Springvale Mine Extension Project
IA059800/061b

Hydrological Advice to PAC Review

Figure 1 : Calibration Time-Series Chart at #047 (Coxs River above Lake Wallace, NSW Office of Water Gauge No. 212054)

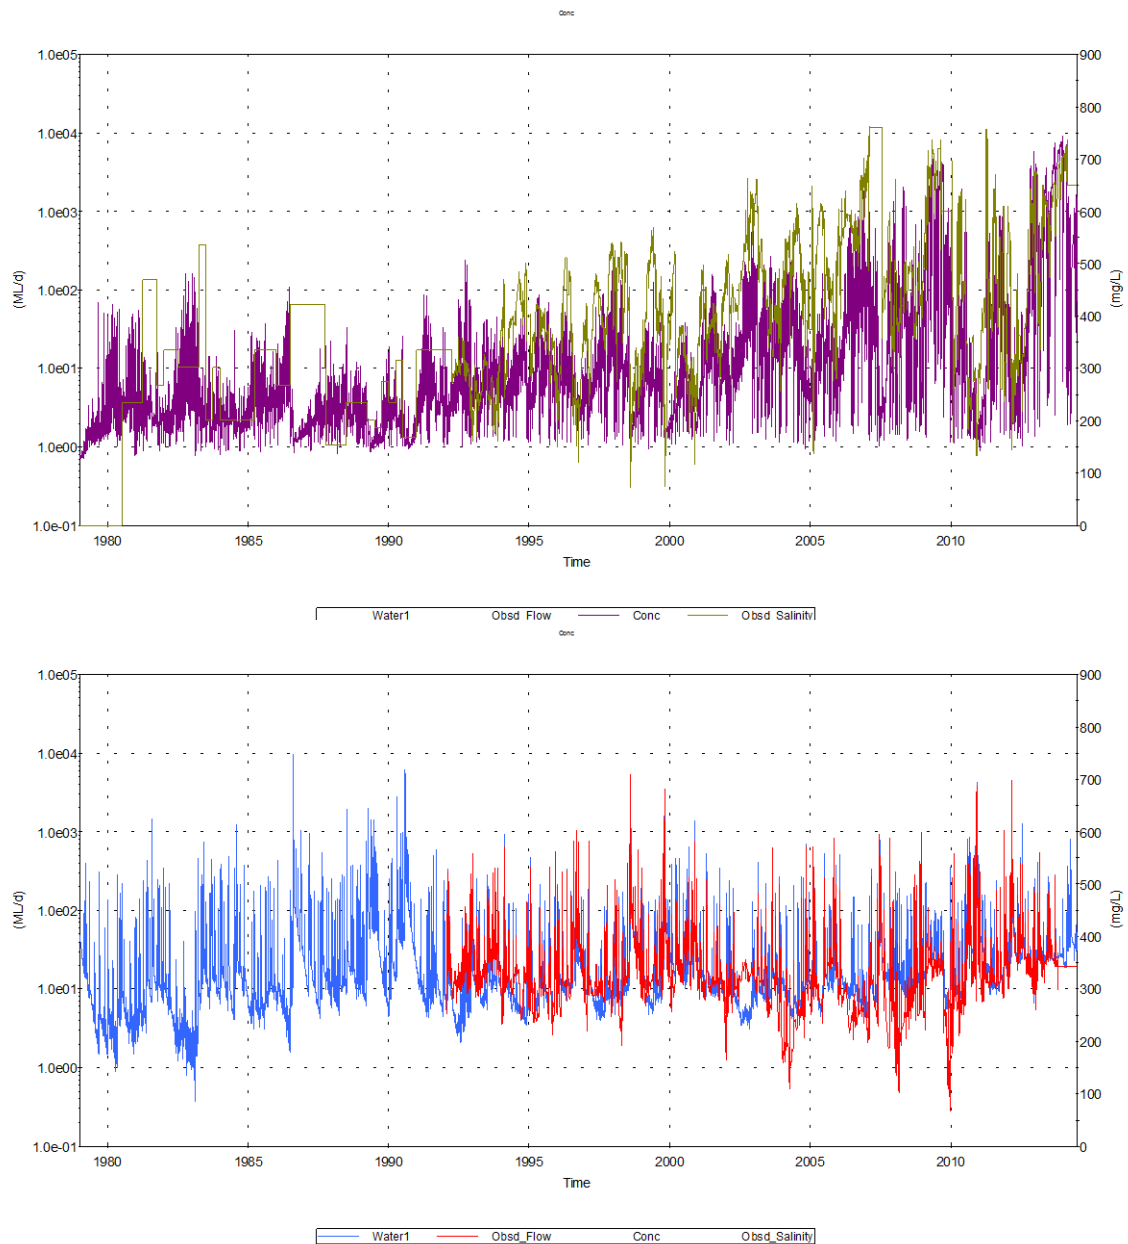
Issue OEH05) *It is clear from the material presented in Jacobs (2015) that the model is poorly calibrated. Figures 3.5, 3.8, 3.9, 3.10, 3.12, 3.16 (salinity), 3.17, 3.20, 3.28, 3.30, 3.32 identify significant underestimation or overestimation of salinity, flow or both salinity and flow are various points (nodes) in the Upper Cocks River catchment. Figures 3.11, 3.14, 3.18, 3.26 and 3.29 potentially exhibit the worst calibrations of all those presented, where real data on flow/conductivity is very poorly matched to model predictions. This is actually identified by the authors (Jacobs 2015) themselves in places where they state:*

- *From Figure 3.14, the water quality model does not encapsulate observed distribution of salinity particularly well (p18)*
- *From Figure 3.17, the modelled fit to observed fit in Lake Wallace has deteriorated in the current version of the water quality model compared to the previous version (p20)*
- *Figure 3.13 indicates the fit of the calibration model to observed data was not particularly close, with the model under-estimating salinity. (p58).*

Figure 3.15 from Jacobs (2015) is reproduced here, as Figure 1, for the purpose of discussion. It is noted that the salinity and flow time-series in Figure 1 have been separated for clarity.

This node (#047) corresponds with NSW Office of Water Gauge No. 212054 and is located upstream of Lake Wallace and is the outlet from the Upper Coxs River catchment. From Figure 1, it is demonstrated that there is an acceptable match between observed and modelled flow and salinity.

Figure 4 : Calibration Time-Series Chart at #032 (Coxs River below Lake Wallace, NSW Office of Water Gauge No. 212008, AWT_E036, EnergyAustralia WX13, SV_COXS_DOWNSTREAM)

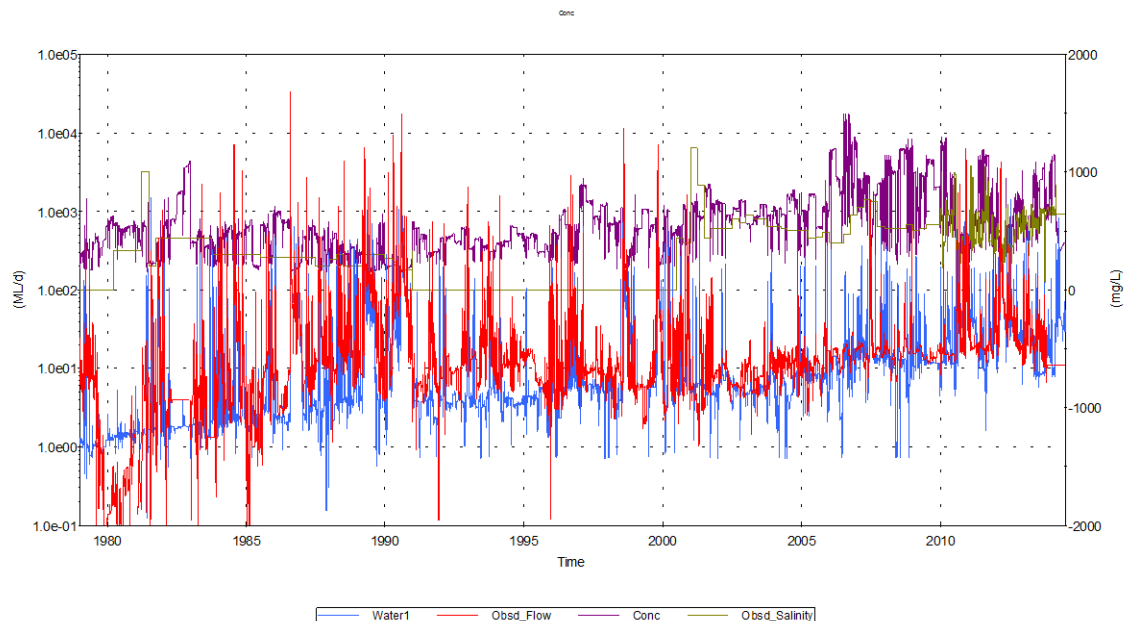
The reasoning behind calibrating flow and salinity in Lake Lyell some 18-20km distant from LDP009 discharge is not considered sound if the model is supposed to be an assessment of the impact of LDP009 (and other Centennial discharges) on the Upper Cocks River. Daisy-chaining of errors from a point in the river 18-20km downstream including passage through 2 major storages is a significant concern and, as a result, errors in the AWBM could be considerable. This is just one potential reason that could explain the poor level of calibration of the AWBM results with real data in many areas.

The model as it currently stands is being presented as an assessment of the impact of the proposal on the Upper Cocks River, but is potentially ignoring the latest localised effects of the mine on the Upper Cocks River (ie in those areas closest to where the LDP discharges occur). The EPA has previously raised concerns about the lack of appropriate upstream-downstream comparisons for each LDP discharge in the Upper Cocks River catchment to assess its true impact on the environment. This lack of appropriate assessment remains since the node immediately upstream of the LDP discharges is rarely if ever compared to the node immediately downstream of the LDP discharge.

The stated approach to calibration (Section 3.2.2 of Jacobs (2015)) reflected a focus on the impact of the Proposal on Lake Lyell, which is the primary water supply reservoir for the Mount Piper Power Station. As mentioned above, the quality of calibration is considered appropriate for the purpose of impact assessment. It is acknowledged in Jacobs (2015) that the calibrated fit in Lake Wallace has deteriorated from the previous version of the model, with reasons stated in Section 3.2.3 of Jacobs (2015). Comparison of inflow to and outflow from Lake Wallace, with upstream node #047 reproduced as Figure 1 above and node #032 not previously presented in Jacobs (2015), presented in Figure 4 below, indicates that the identified issue in Lake Wallace is not particularly significant.

The potential reasons for the misfit in Lake Wallace are stated in Section 3.1.2.5 of Jacobs (2015), *“As indicated in Section 2.3 of RPS (2014a), Cooling Tower blowdown at Wallerawang Power Station was discharged to Lake Wallace (EnergyAustralia LDP001 and LDP021) but the majority was discharged below Lake Wallace (EnergyAustralia LDP004). At Node #086, upstream of Lake Wallace, there was discharge from EnergyAustralia LDP001, based on available record and was extrapolated as required. EnergyAustralia LDP001 was included in the previous model and was not changed in the current model. EnergyAustralia LDP021 is an emergency discharge location and was not included in the model. The available record indicates flow ranging from 0ML/d up to 15ML/d on a sporadic basis, with salinity of ~1000mg/L. This may partially account for observed under-prediction of salinity in Lake Wallace in the water quality model.”*

In regard to OEH's comment on localised effects of the mine on the Upper Coxs River, calibration and model predictions in both RPS (2014) and Jacobs (2015) are presented with respect to each tributary.
